PRE-APPLICATION CONFERENCE NOTES

Quattro Ridgefield Retail

File No. PLZ-22-0122

PRE-APP SITE PLAN

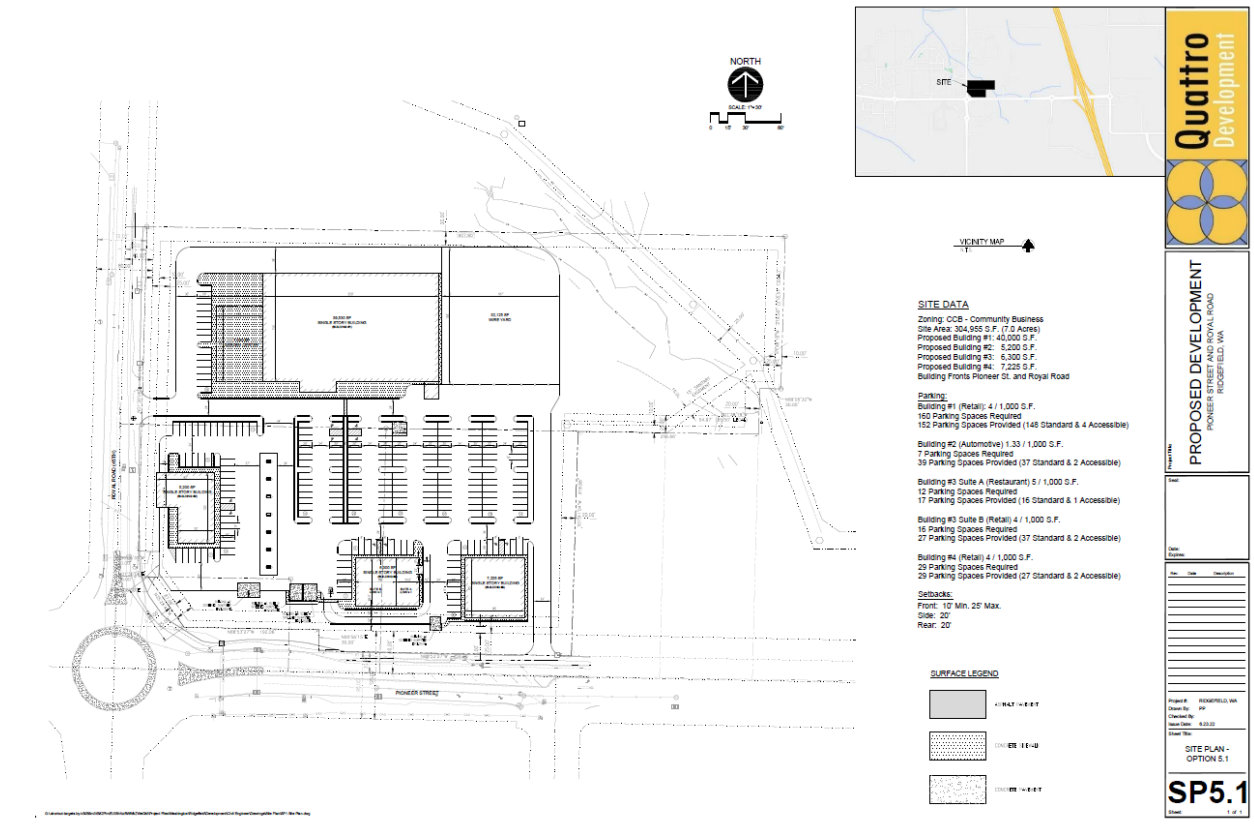
Comment: The applicant hasn't shown whether each building will be on its own lot or if the lots will be combined. In addition to a legal lot determination, a lot combination and a boundary line adjustment may need to be complete concurrently with the site plan review. In addition, the current proposal does not comply with maximum setback requirements.

Comment: The maximum setback is exceeded on the proposed plan. Show how these standards will be met or submit for a modification under RDC 18.350. In addition, a landscape plan will need to be provided showing these standards have been met.

Comment: The trash enclosures will need to be relocated to an area of the site least visible from the public right-of-way. In addition, loading areas will need to be shown on the preliminary plan.

Comment: This section is applicable to drive-through facilities. Building 3 appears to have a drive through lane that may not comply with these requirements.

Comment: Building 1, a 40,000 square foot retail building, would require 114 stalls and two (2) loading berths. Building 2, a 5,200 square foot automotive building would require seven (7) parking stalls and one (1) loading berth. Building 3, consisting of retail and a restaurant building would require 16 for the restaurant and nine (9) for the retail portion with one (1) loading berth. Building 4, a 7,225 square foot retail building would require 21 parking stalls and one (1) loading berth. Per the preliminary calculations, 167 parking stalls would be the minimum required including six (6) ADA stalls. With the current proposed buildings, loading areas will need to be identified on the site plan.

Comment: The applicant is proposing the main access off of N Royle Road which is the lesser classified roadway (minor arterial). There appears to be an entrance off of Pioneer Street (principal arterial) that engineering will address.

Comment: Building 1 appears to have outdoor storage. Please show that the standards above have been met.
